# SITE PLAN REVIEW AND APPEARANCE BOARD

### ---STAFF REPORT---

MEETING DATE: January 27, 2016

ITEM: Class III Site Plan Modification for **Wood and Fire Restaurant** associated with interior and exterior renovations, parking lot and landscaping improvements for the existing "Fisherman's Grill" outparcel located on the north side of West Atlantic Avenue in the Marketplace of Delray shopping center.

**ATLANTIC AVENUE** **PROPOSED SITE PLAN**  
 SCALE: 1" = 10'-0"

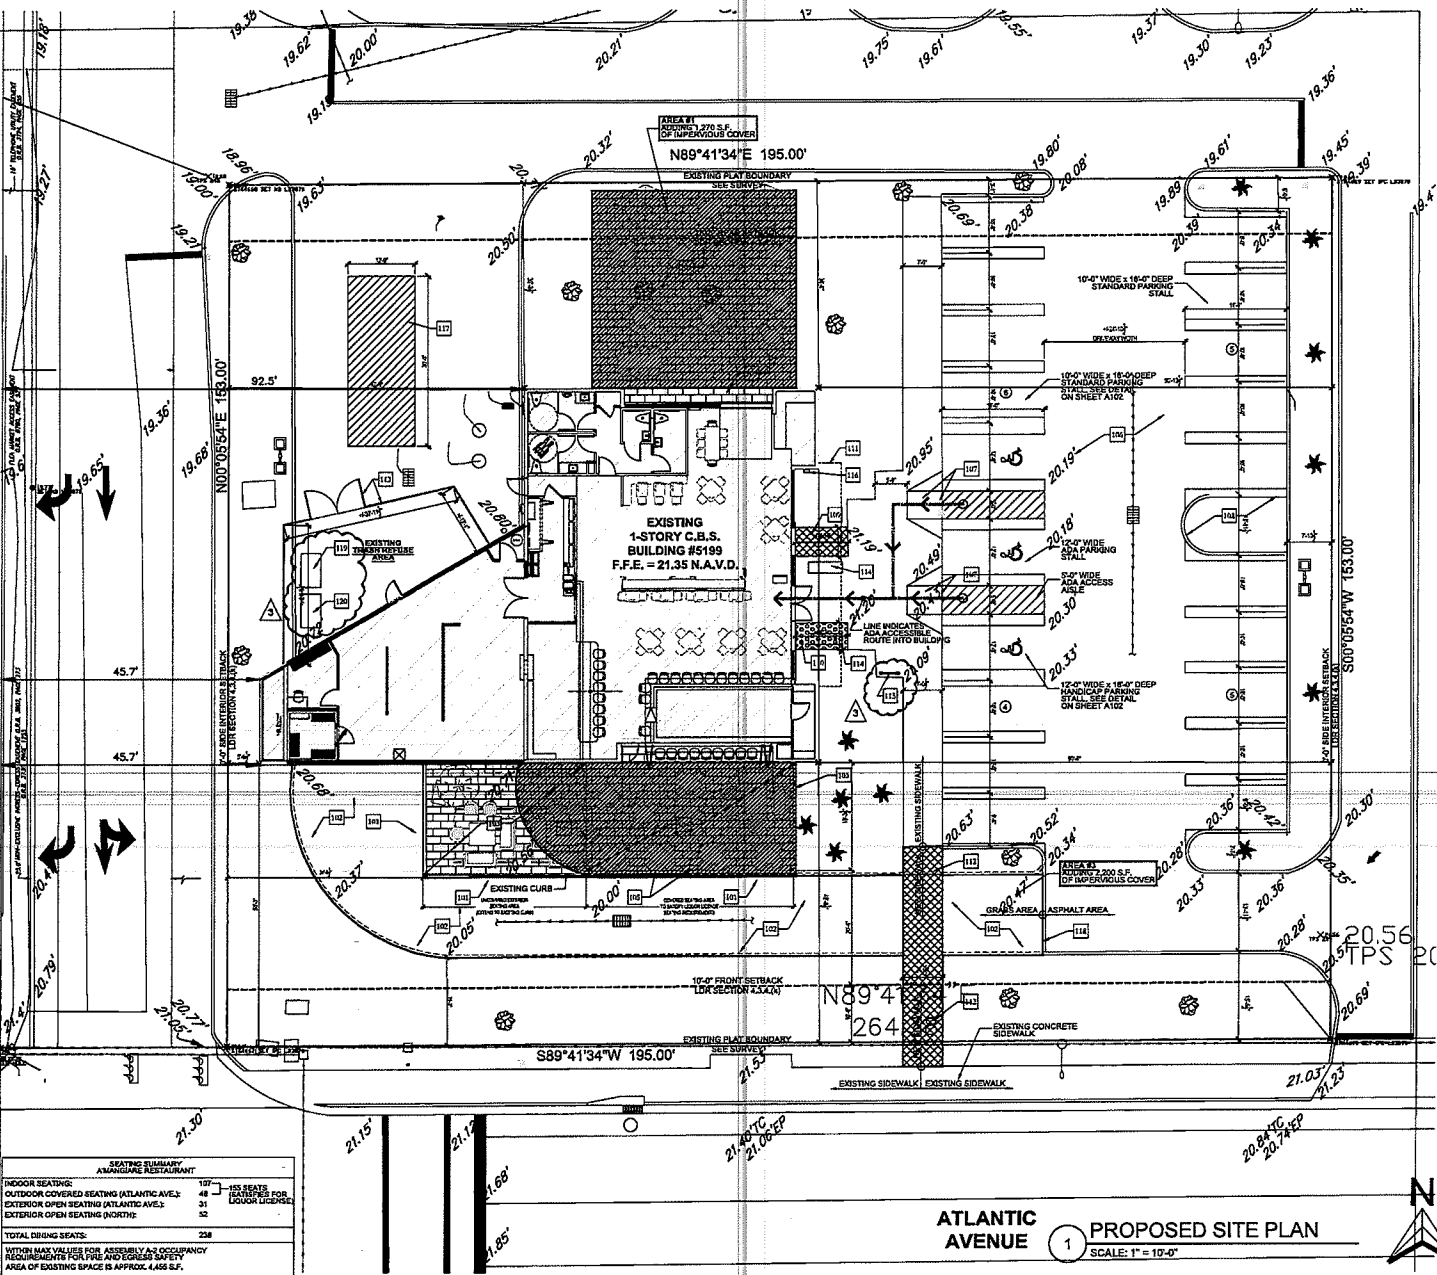
1. Summarize the parking requirement consistent with the staff report and update the site data chart on the site plan. Include a subtotal (2,707 sq. ft.) for proposed new outdoor use areas.
2. Illuminate the outdoor use areas for compliance with LDR Section 4.6.8(A)(3).
3. Revise the underlying site plan layout for the photometric plan to be consistent with the plans set.
4. All submitted plans must be oriented the same way on a 24" x 36" sheet. Make all plans consistent.
5. All plans shall be at the same engineering scale per LDR Section 2.4.3(B)(1). Redraw the landscape plan to match the balance of the plan set at 1"=10'. It is currently drawn at 1"=30'.

6. Pursuant to LDR Section 4.6.9(E)(5), for the outparcel to sustain its current parking requirement, a cross access easement agreement is required to be recorded with Palm Beach County.
7. There are still some discrepancies in the curbing provided separating the landscape, hardscape and parking areas. Modify all plans to reflect intentions and update all plans accordingly for consistency.
8. All plans must graphically depict double line curbing along the raised sidewalk in front of the parking row facing the building, unless wheel stops are proposed.
9. All plans must clearly show that the landscape island terminating the southern end of the parking row in front of the building is being removed and replaced with "Type D" curbing.
10. All parking spaces on all plans must be depicted as double-striped pursuant to the detail in LDR Section 4.6.9(D)(6)(e).

**SITE PARKING LIGHTING & PHOTOMETRIC PLAN**  
SCALE: 1" = 10'-0"

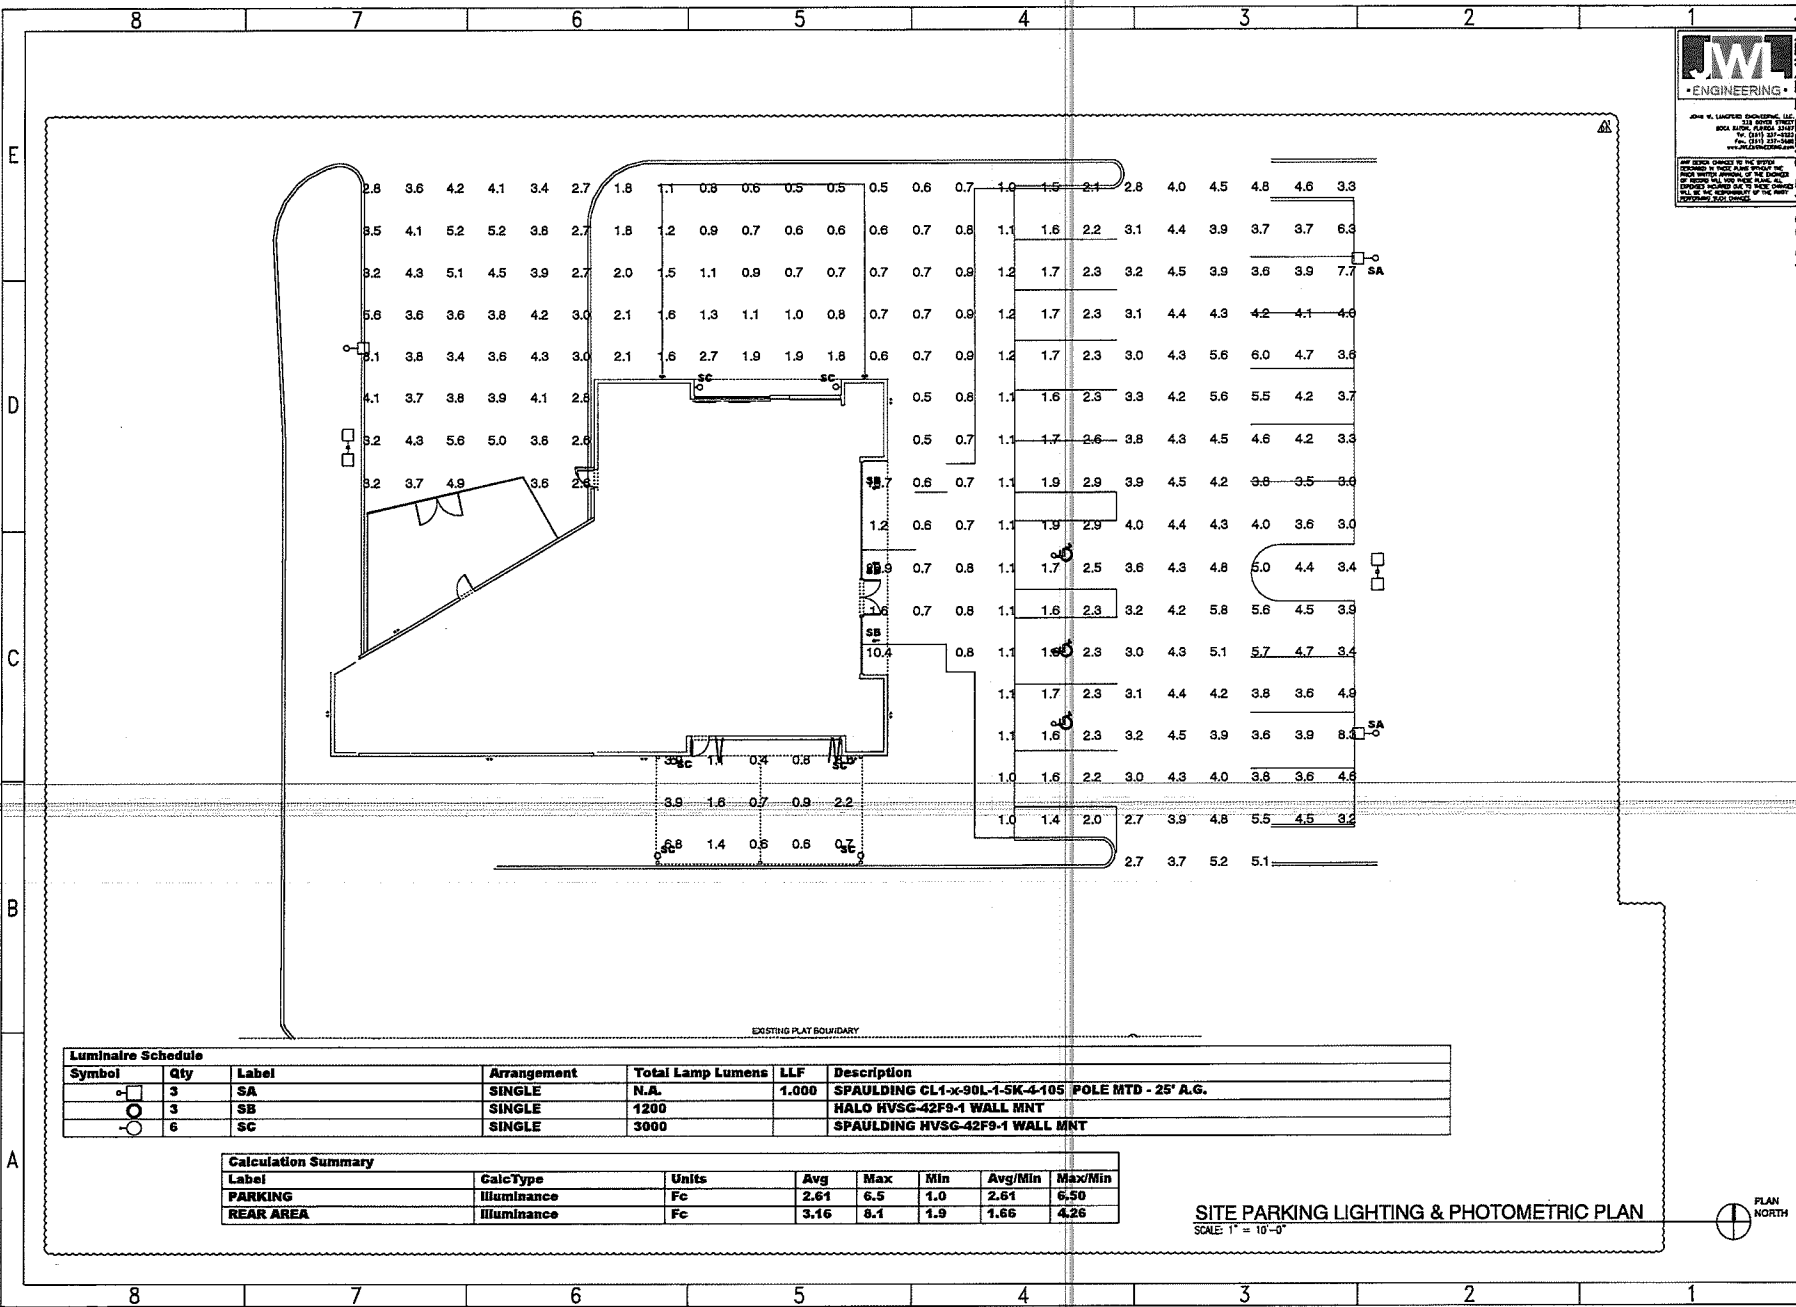
Pursuant to LDR 4.6.8 (Lighting), pole and wall mounted site lighting must be provided. The applicant is required to identify the source of lighting in all outdoor use areas and provide the point calculations. These have been omitted for the trash enclosure entrance and use area. Provision of point calculations in this area which meet the minimum and maximum standards is a condition of approval. Similarly, the underlying site plan layout for the photometric plan is inconsistent with the balance of the plan set. This shall be corrected for consistency, prior to site plan certification. This is a staff recommended condition of approval.

1. Address all site plan technical items identified in the staff report and submit four copies of revised plans for site plan certification.
2. Revise the underlying site plan layout for the photometric plan to be consistent with the plan set.
3. Pursuant to LDR Section 4.6.9(E)(5), for the outparcel to sustain its current parking requirement, a cross access easement agreement is required to be recorded with Palm Beach County.
